Briefing Note

Our ref 63262 STDC NZT 20971461v1
Date 6 May 2022
To Redcar and Cleveland Borough Council and Environment Agency

Subject **Response to comments from the Environment Agency on Planning Application Ref: R/2021/1048/FFM - 'Engineering operations associated with ground remediation and preparation of the site'**

SUBJECT
Land to West of Warrenby Redcar – Response to (EA document reference NA/2021/115684/02-L01)

Drawing Number: TSWK-STDC-NZT-ZZ-DR-C-0005 Revision: **C**

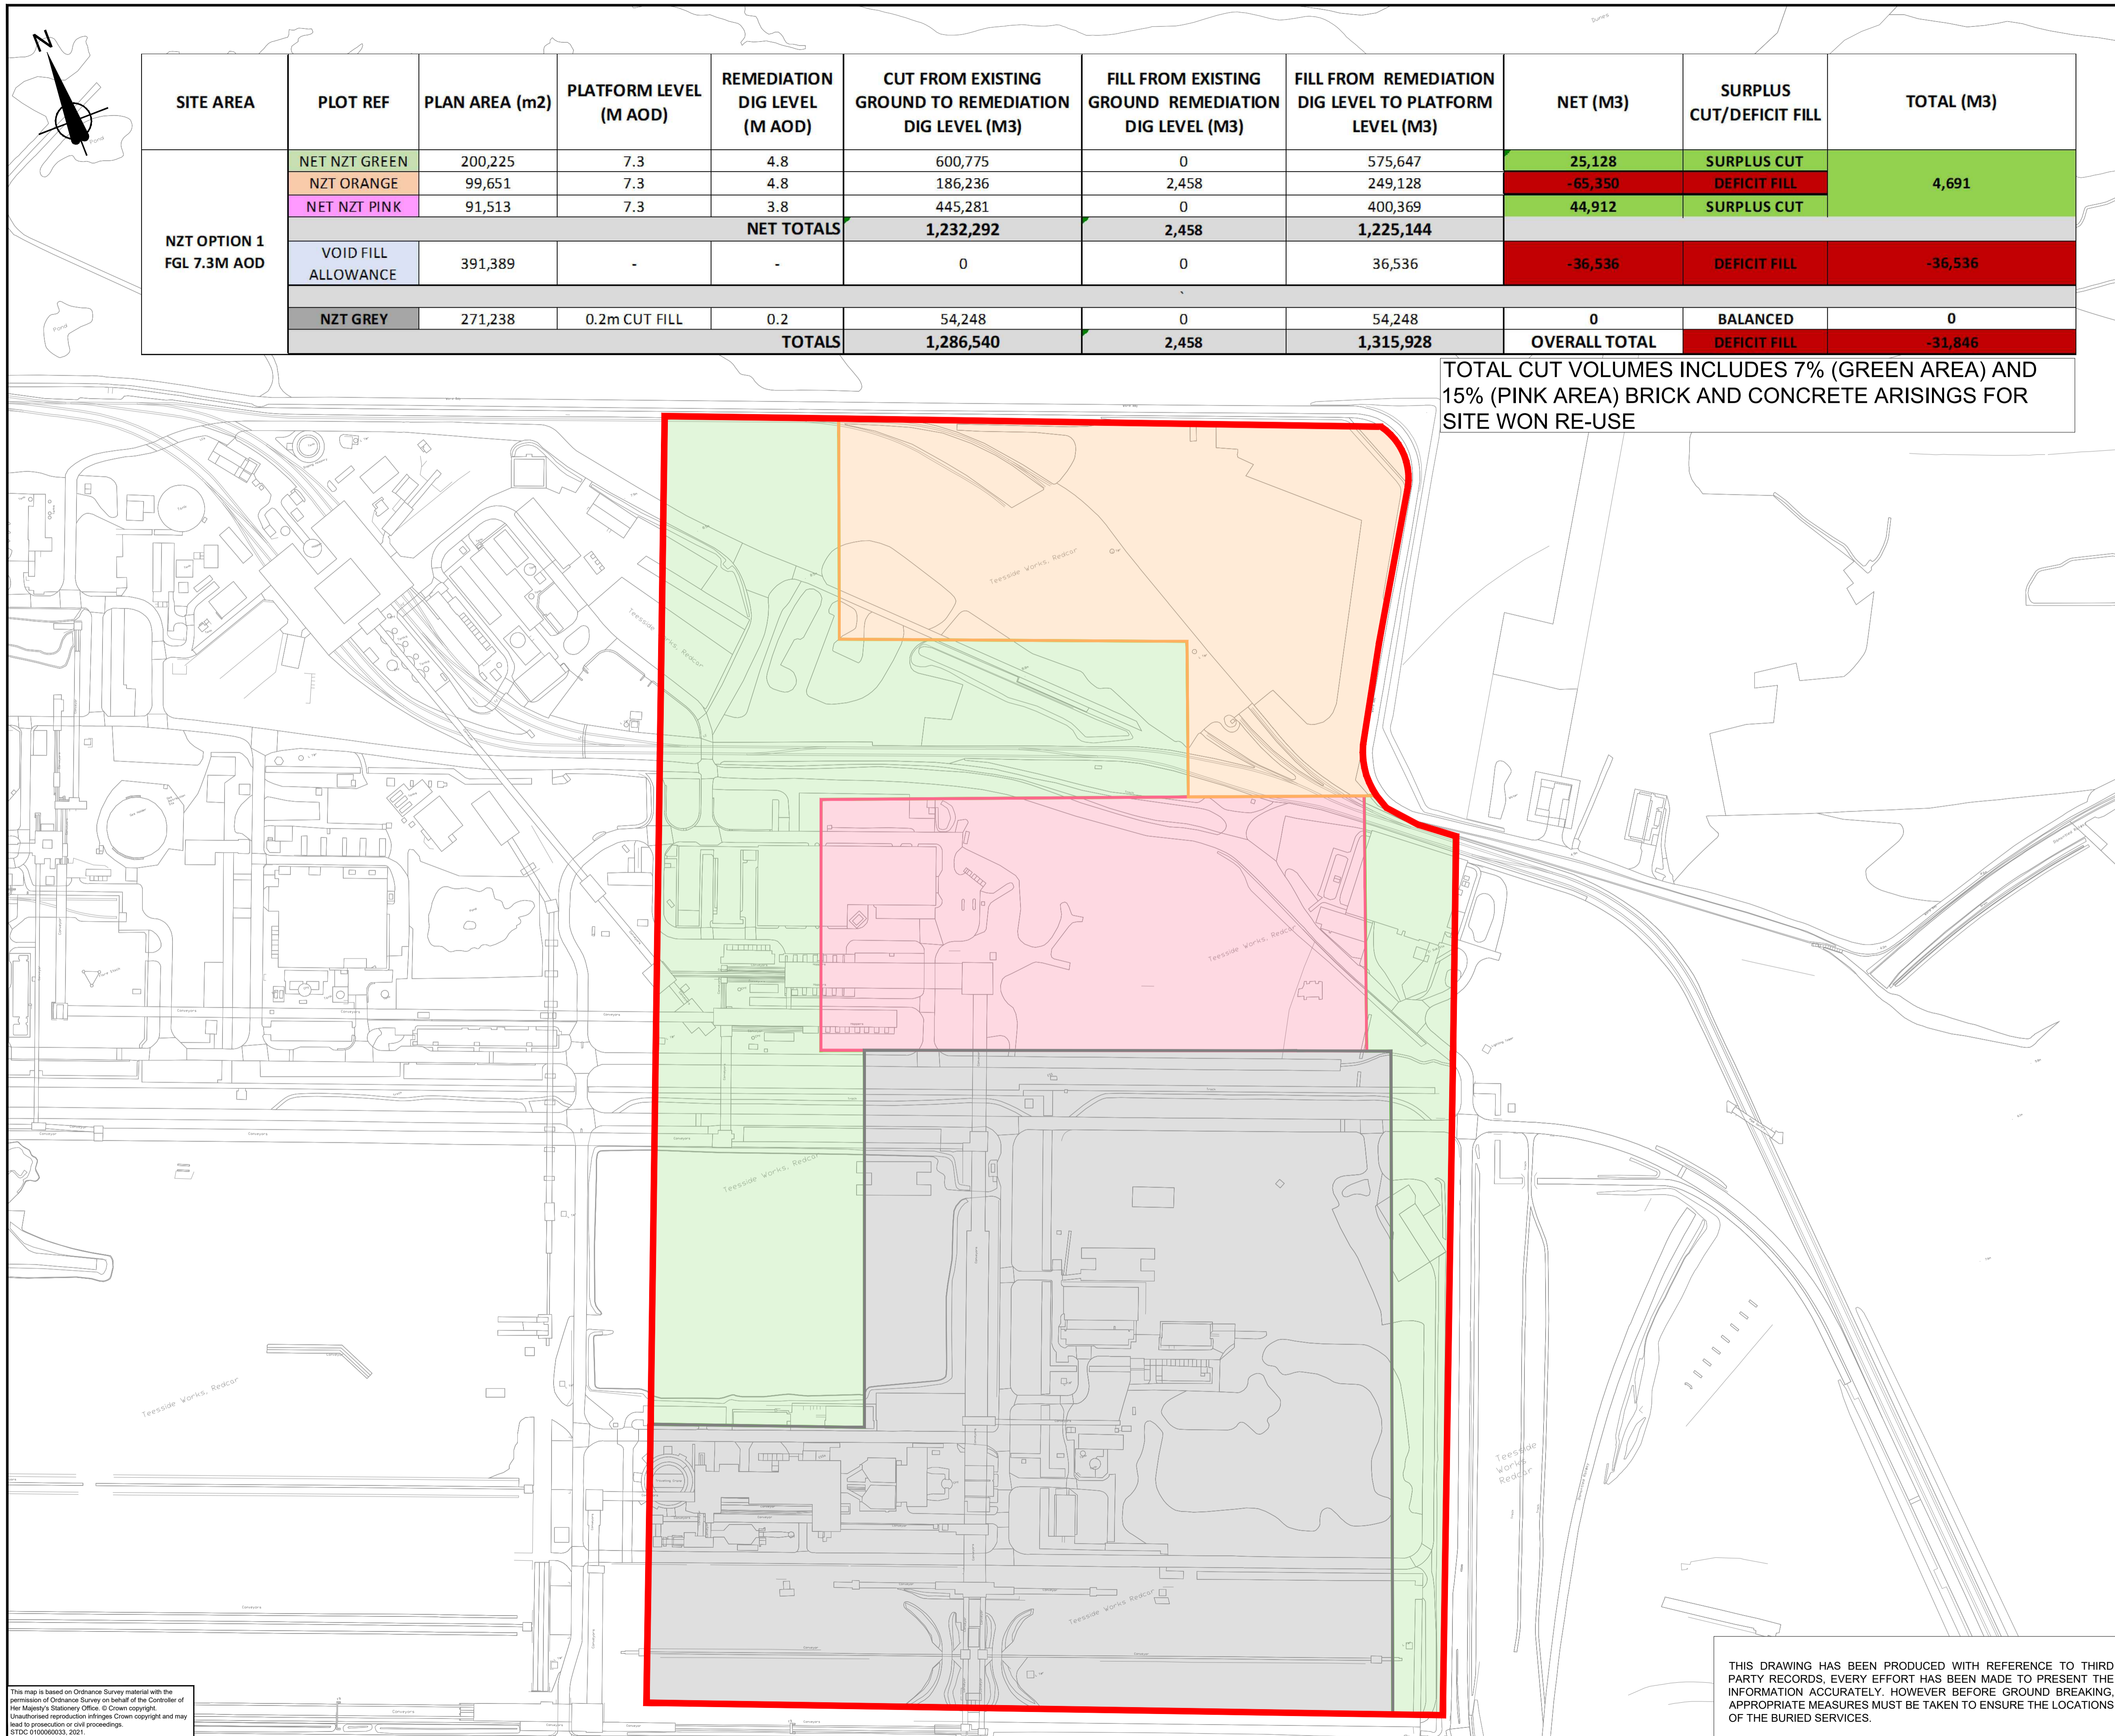
As discussed in the meeting between the EA, STDC, Lichfields, Arcadis, and Atkins held in the Teesworks Management Office (TMO) on 30/03/22 remediation is not proposed in the grey area, as shown on drawing *TSWK-STDC-NZT-ZZ-DR-C-0005 Net Zero Teesside - Remediation Zones - Rev B* (provided as Appendix 3). As part of the works undertaken under this Application a suitable cover system is to be installed across the grey area to make it suitable for construction / laydown activities prior to the current intention of being leased to the Net Zero developer for a period of approximately 4 years.

Remediation of the grey area will be undertaken at a later date under a separate planning application.

Appendix 5 - Net Zero Data Gaps plan

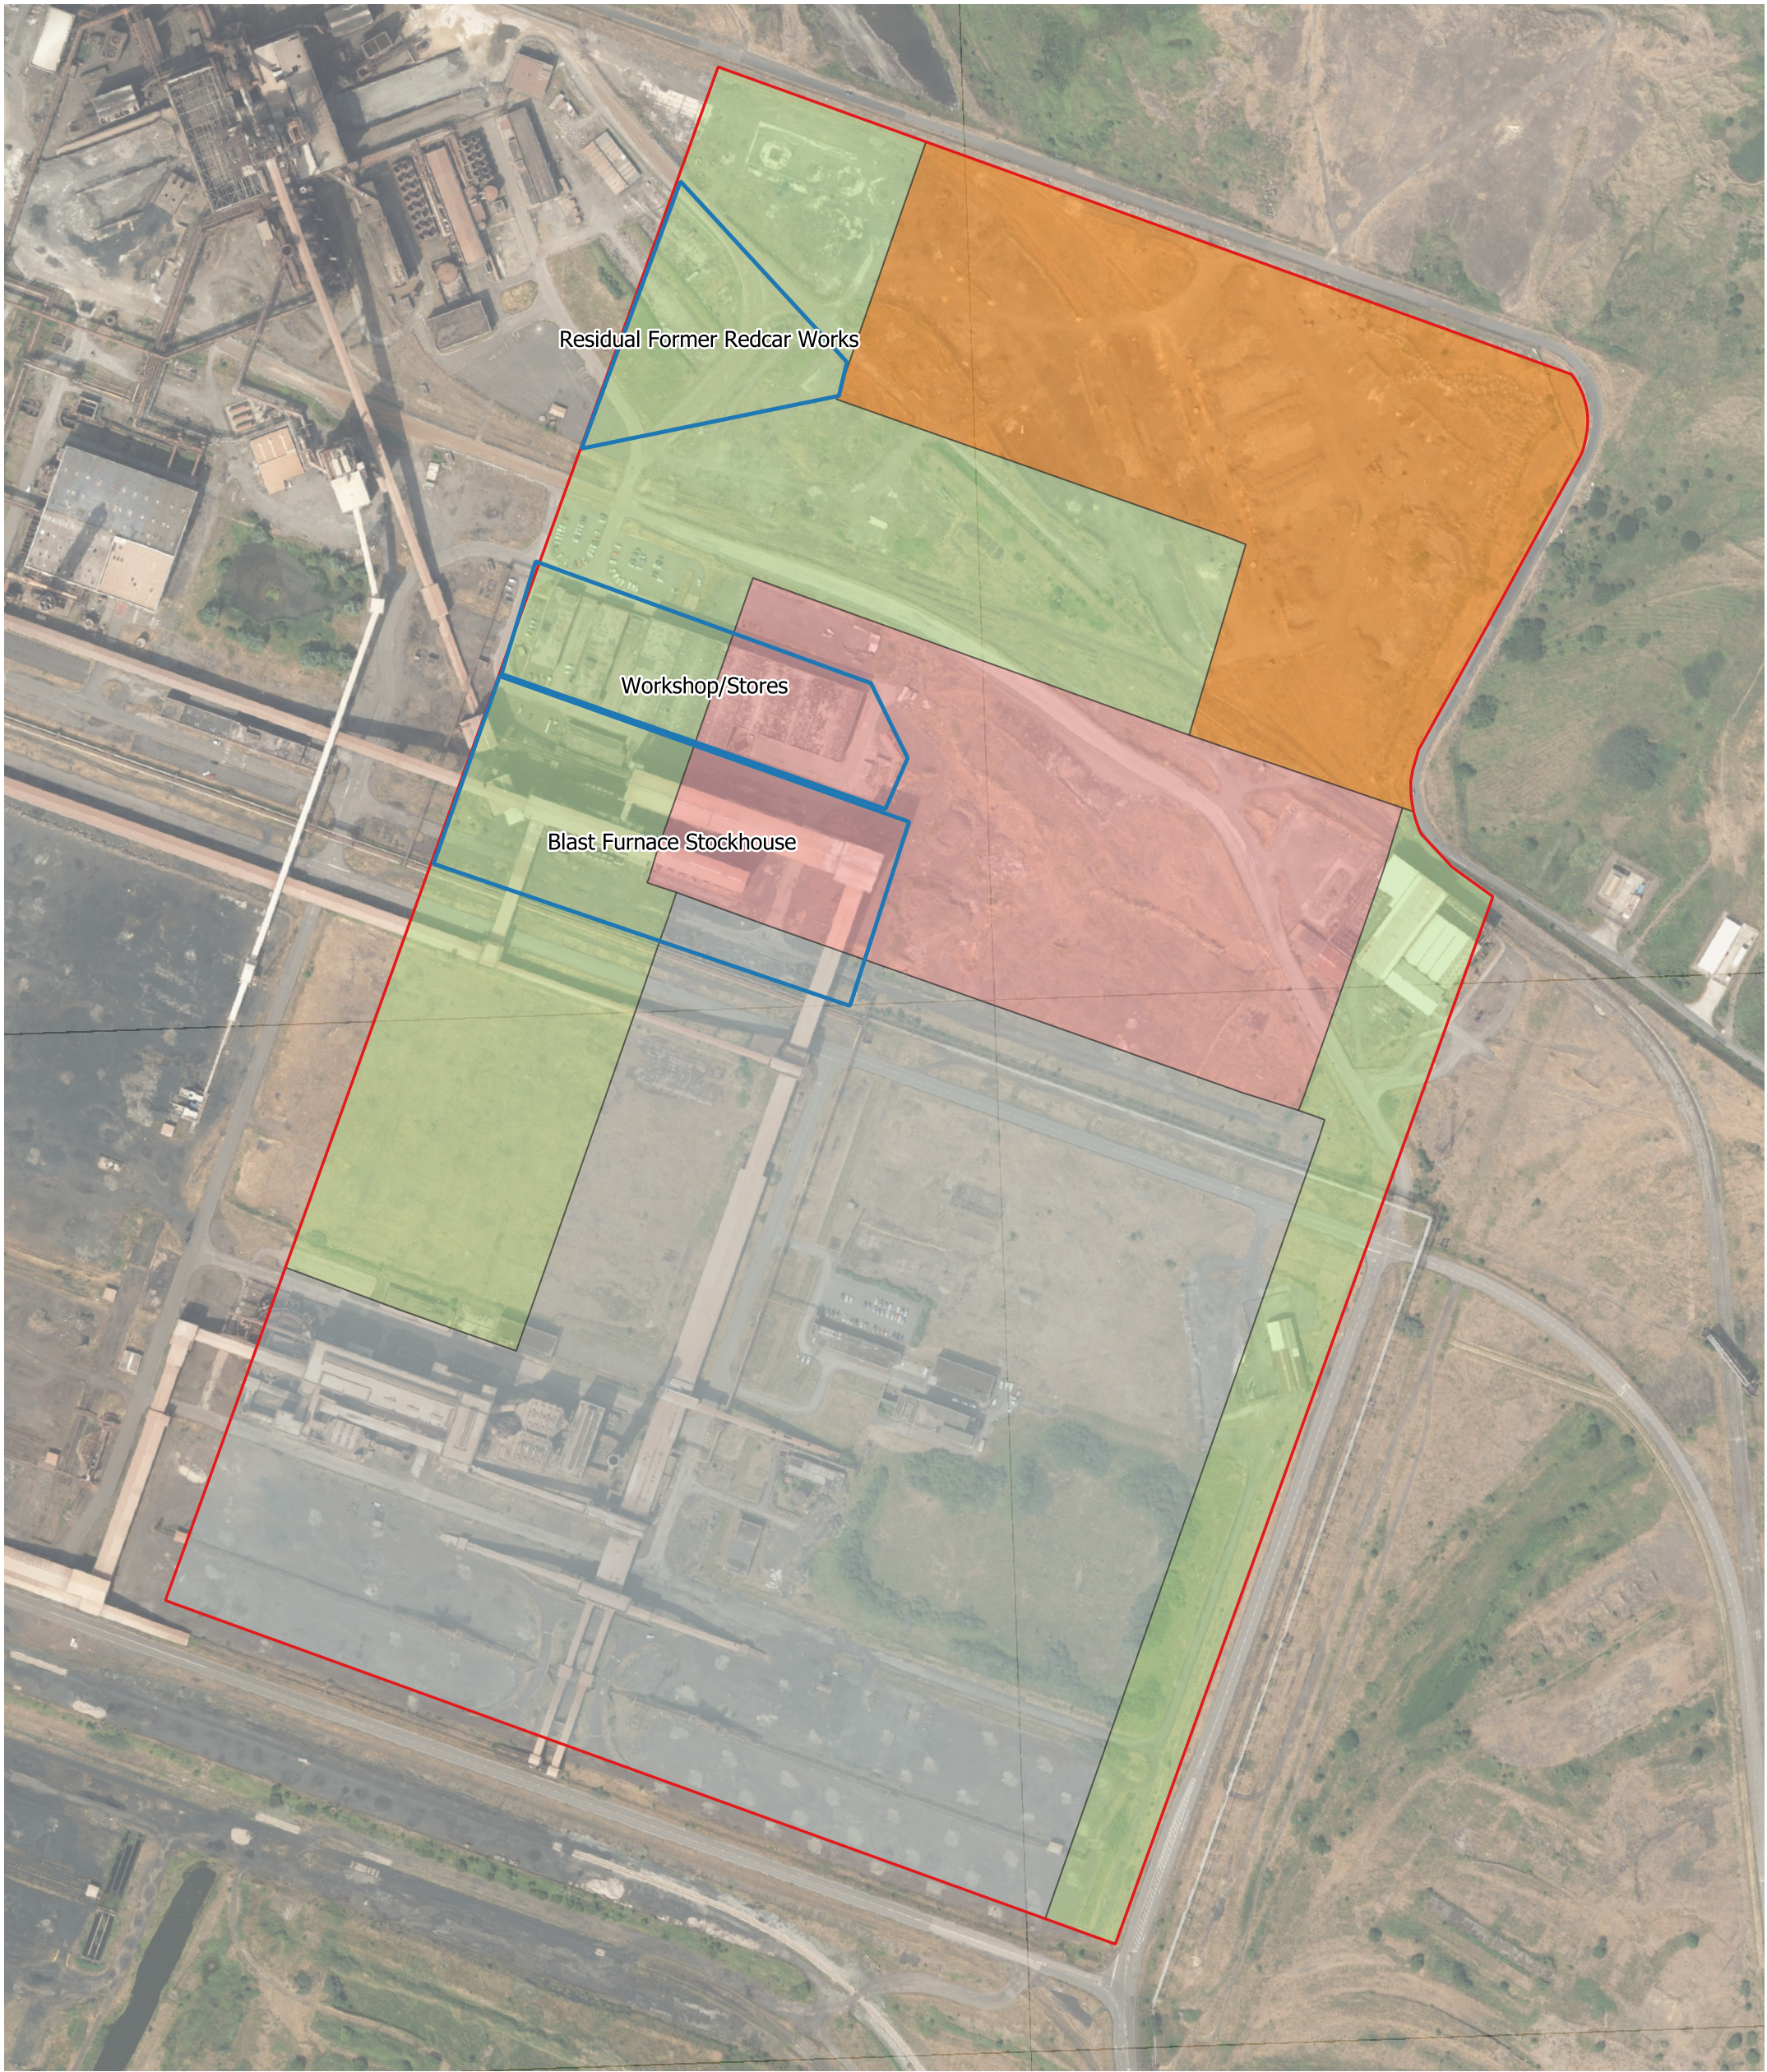
1. No development hereby approved shall commence within the areas outlined in blue on the submitted 'Net Zero Data Gaps' plan (Plan Ref. No. 10035117-AUK-XX-XX-DR-ZZ-0508-01-Net_Zero_Plot_Data_Gaps) until a report of findings arising from Phase II intrusive site investigations including a risk assessment (generic or detailed quantitative assessment as required), and if required by the risk assessment an updated Remediation Strategy have been submitted to and approved in writing by the Local Planning Authority (the submitted information shall consider the areas within the blue lines shown on the aforementioned plan only). The Assessment shall include measures and timescales for Remediation, Monitoring and Verification Reports include mitigation measures.
